# CO-OP MINING CO.

## MODIFICATION SUBMITTAL

The following material is in answer to the deficiencies as stipulated by the Division in their letter of May 12, 1983, and also of February 3, 1983 regarding the modification to the Bear Creek Canyon Mine permitting.

SCALE AREA MODIFICATION RESPONSE  
BY  
CO-OP MING COMPANY  
BEAR CANYON MINE

Figure 1. Soil erodibility nomograph.

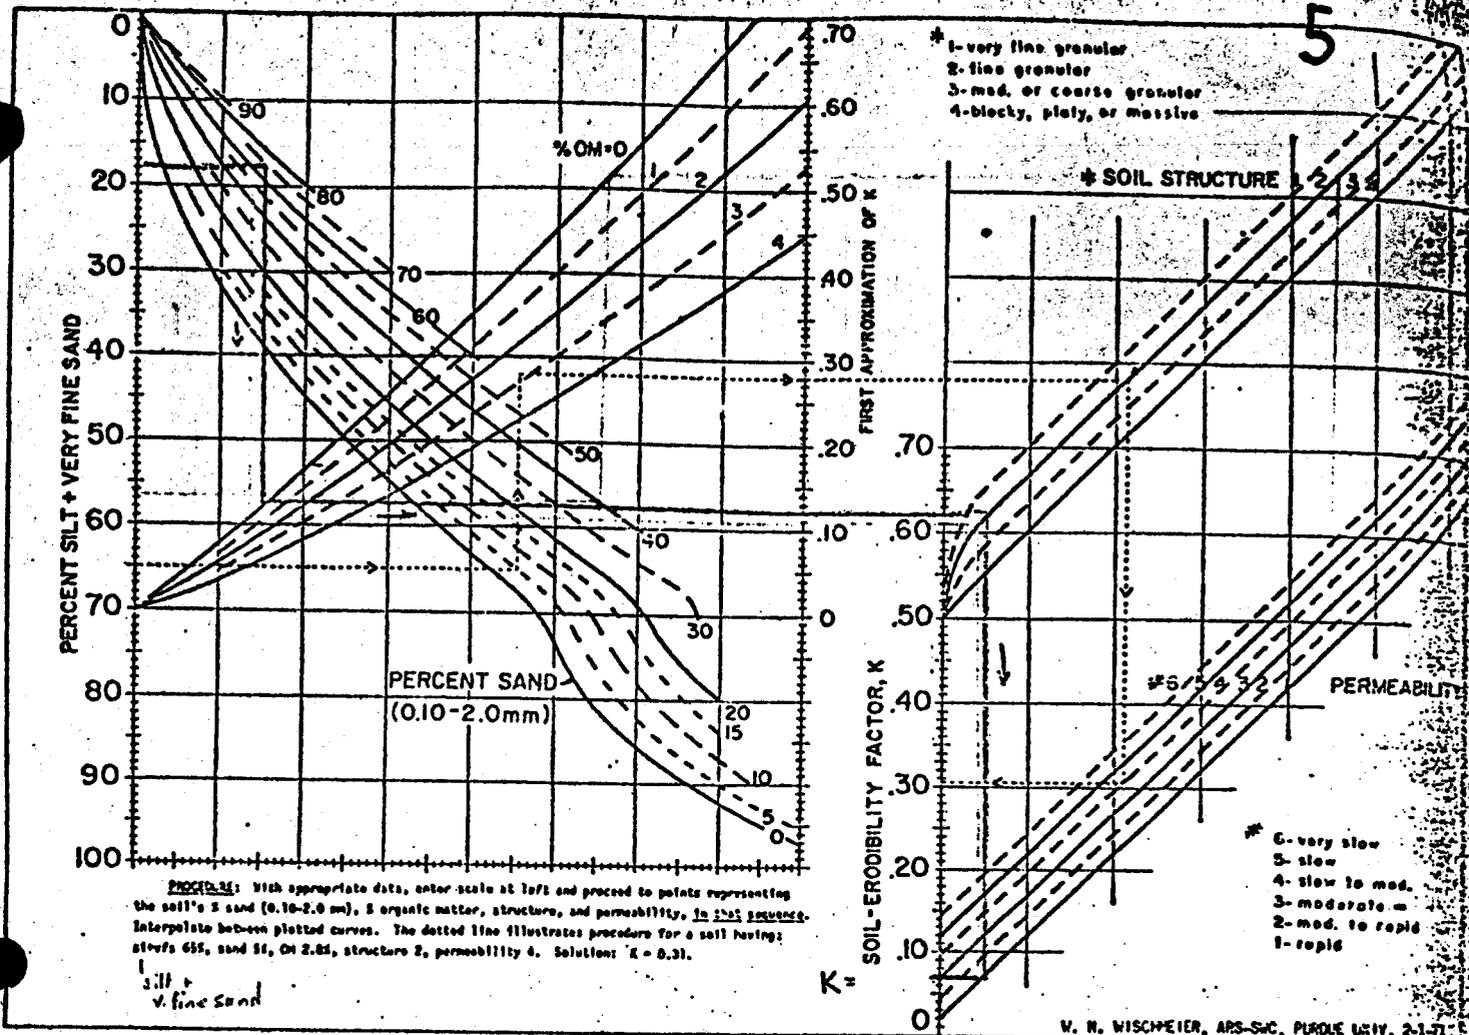
K: Soil erodibility factor was determined by using an SCS approved Soil Erodibility Nomograph, (developed by Dr. W.H. Wischmeier, ARS-SWC-Prudue University) This method is accepted by both the U.S. Forest Service and O.S.M. The soil Nomograph is enclosed.  
57% silt and fine sand (.10 to 2mm)  
39% sand  
4% Organic matter  
Moderate fine gradular (2)  
Permeability - moderate (3)

$$K = .29$$

SCALE AREA CATCH BASIN

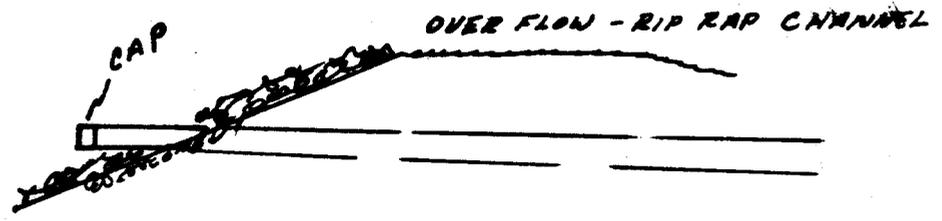
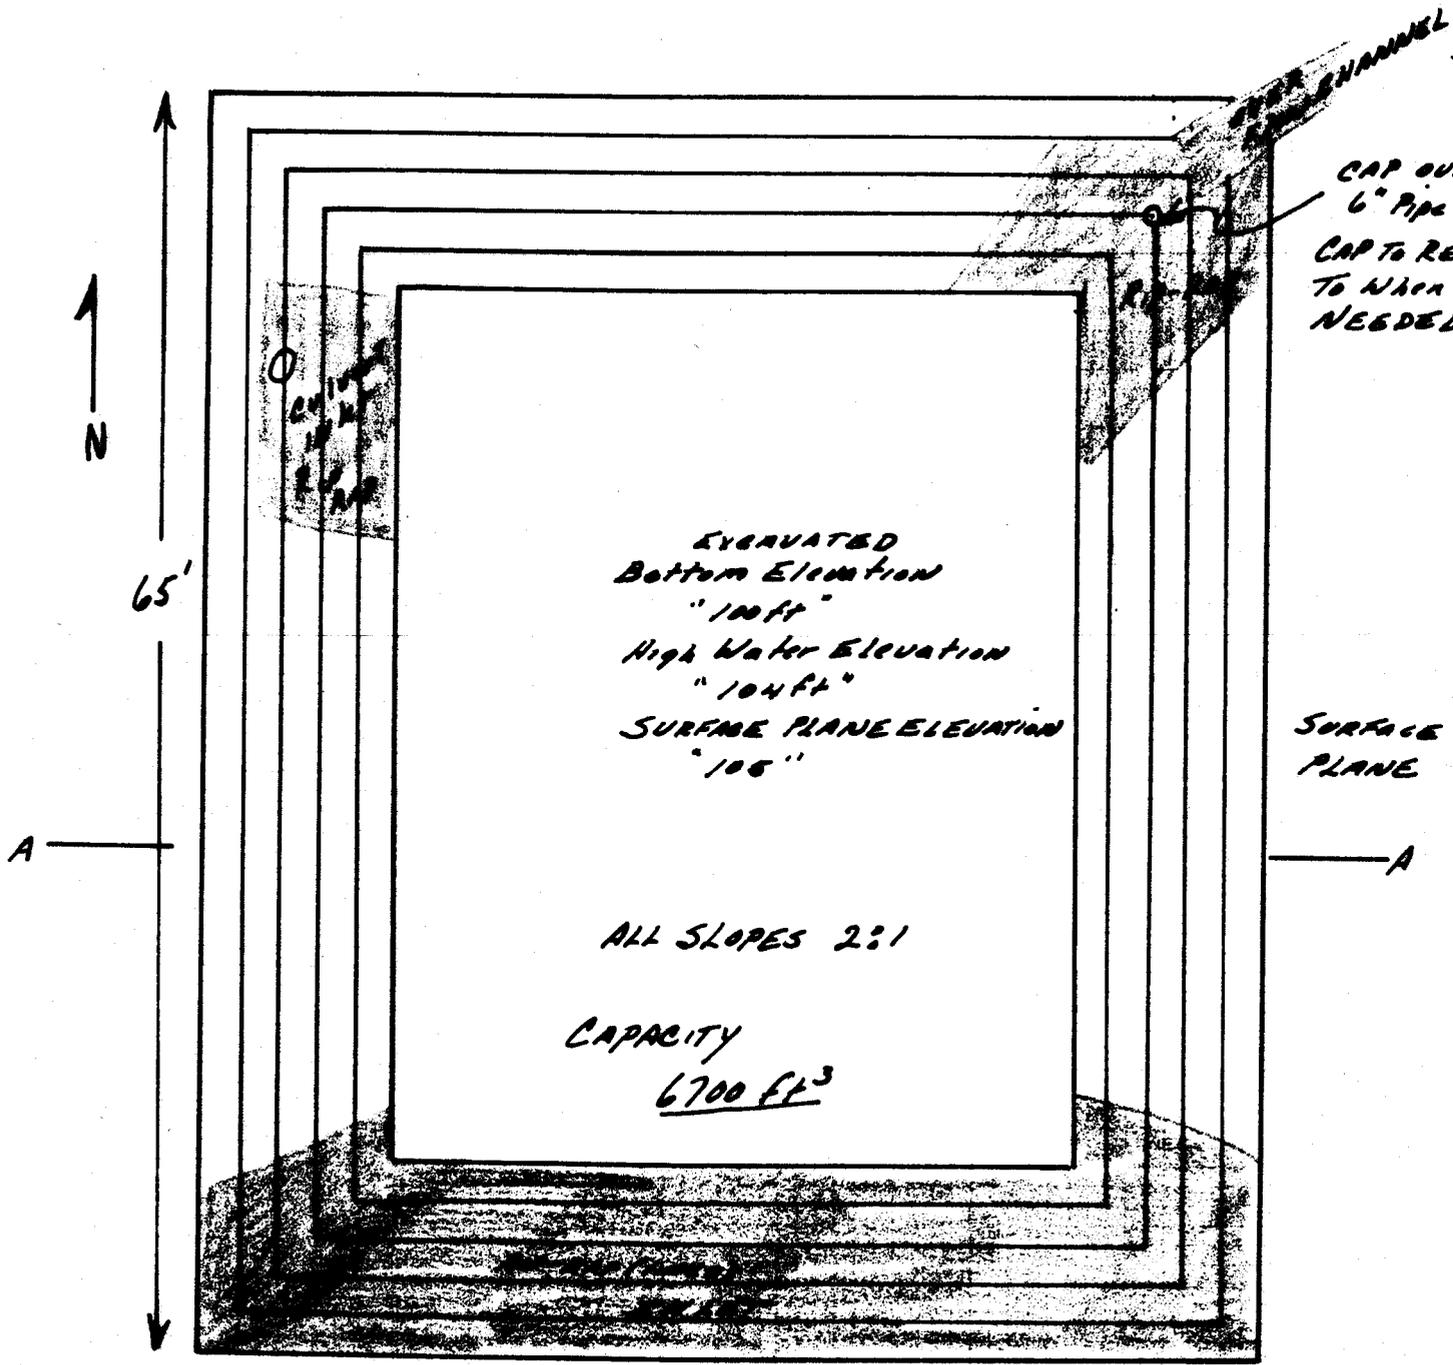
Please review the enclosed 2ND SUBMITTAL for the catch basin design, it has all the details you have requested.

- 1 and 2 were addressed in the 2ND SUBMITTAL for the Catch Basin.
3. Violation 3 of 3 for NOV 83-5-3-3 was not concerned with the catch basin. Seepage protection in the basin will be accomplished by compaction and brattice - rip-rapped lining of key areas.

The pond will be a completely excavated. With all slopes at 2:1 as required. All slopes and bed will be compacted. From the bottom of the basin to the top of the slopes the vertical difference will be 5ft. 1 foot is to be considered as the free board. Along the top of the slopes the pond measures 55ft by 65ft. The pond emergency overflow will be a 4ft. wide rip-raped (lined) channel in the south west of the pond. The lining will be brattice cloth with heavy rip-rap. The channel will begin at a 4ft elevation above the pond base floor. After leaving the basin the overflow channel will descend to the creek on slopes no greater than 2:1, and heavy with rip-rap. A six inch decant pipe will be placed through the embankment, below the emergency spillway. The pipe level will begin a 2ft. above the pond base. Rip-rapping will take place along all inlets. Brattice line will be placed on the critical areas for seepage problems. The enclosed drawing will help insure understanding.

PRE-CULVERT INSTALLATION CROSS SECTION

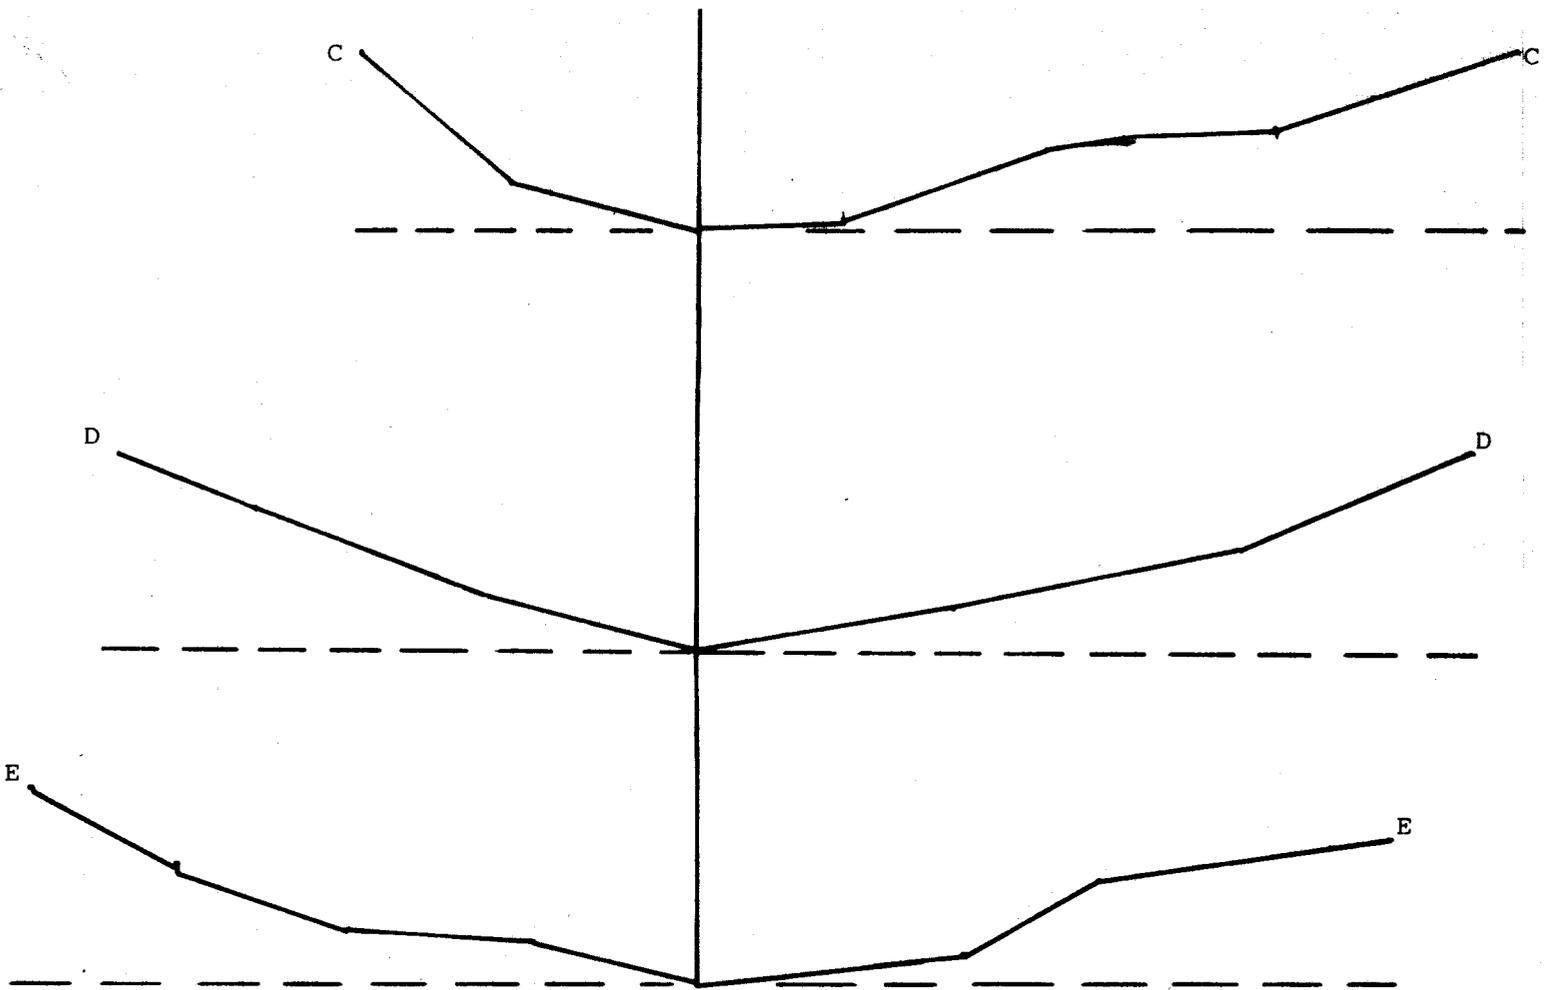
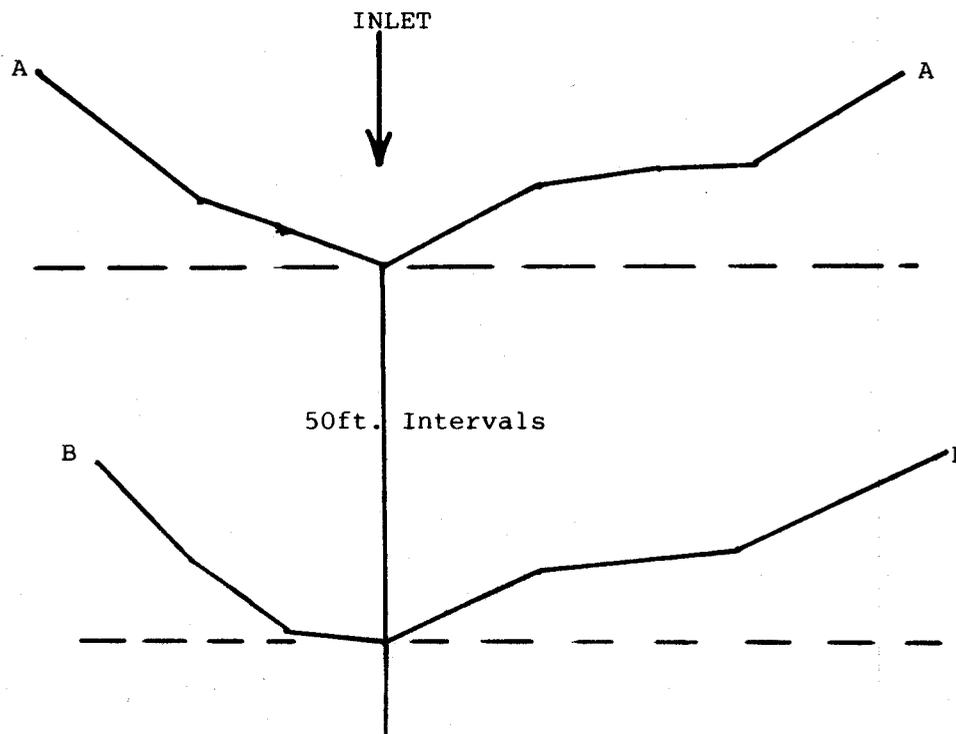
4. Desin detail for the 60 in. culvert
- A. The culvert will only extent 200ft. Note drawings
  - B. The culvert is to be a 60 inch concrete pipe. The slope relationship can be determind by crossection and headwall drawings.

The septic tank is no longer a concern, and the length of the culverts has been reduced to 200ft.
